BG #: 15-017 Change Order No.: 8-7  
 District: Henderson County District Code: 251 Facility Name: HENDERSON CO. HIGH SCHOOL - KY TECH CAREER AND TECHNOLOGY School Code: 60  
 Project: HENDERSON CO. HIGH SCHOOL - KY TECH CAREER AND TECHNOLOGY Time Extension Required: ☐ Yes ☒ No If yes, by \_\_\_\_\_ day(s)  
 Date of Change Order: Tuesday, March 08, 2016 Change Order Amount: ☒ Increase ☐ Decrease ☐ Unchanged  
 Contractor / Vendor Name: MECHANICAL CONSULTANTS, INC. Bid Package No.: 008

## Change Order - Construction Manager-Adviser Edition

**PROJECT** (Name and address):  
 HENDERSON CO. HIGH SCHOOL - KY TECH CAREER  
 AND TECHNOLOGY  
 2424 ZION ROAD  
 HENDERSON KY 42420

**CHANGE ORDER NUMBER:** 8-7  
**INITIATION DATE:** 3/8/2016

# Single Deflection Supply Grille

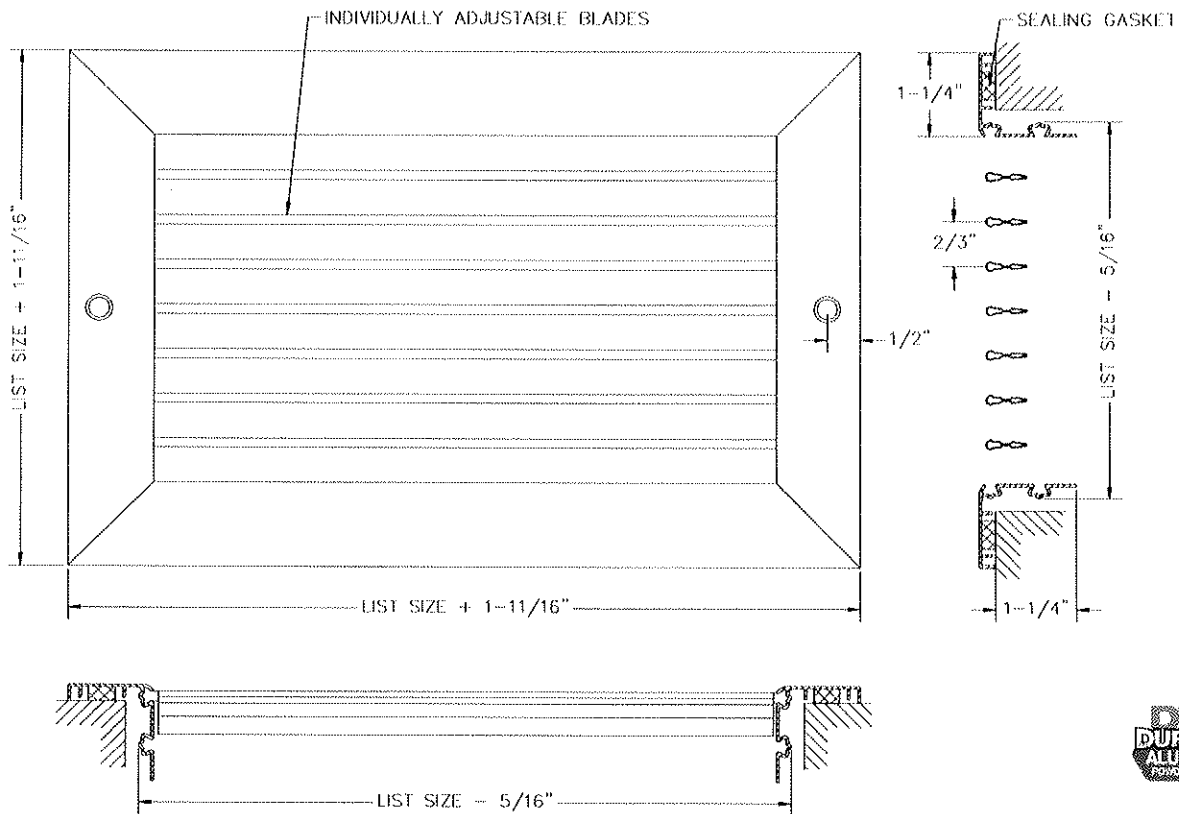
The make-up air duct over the classroom is shown on the drawings as still active. These four supply grilles (24 x 48 each) need to be capped off.

The make-up air unit has eight (8) supply grilles. Capping the duct over the classroom will reduce the supply grille openings by 50%. The existing supply grilles are of a design that have a very low percentage of free area. Additionally these grilles are dirty that further restricts the free area of air flow. The discussion on site was that the grilles need to be replaced with supply grilles with a high free area.

The existing MUA unit is rated for 12,000 CFM for each of the existing grilles will need to handle 3000 CFM.

Attached is a submittal for four new supply air grilles.
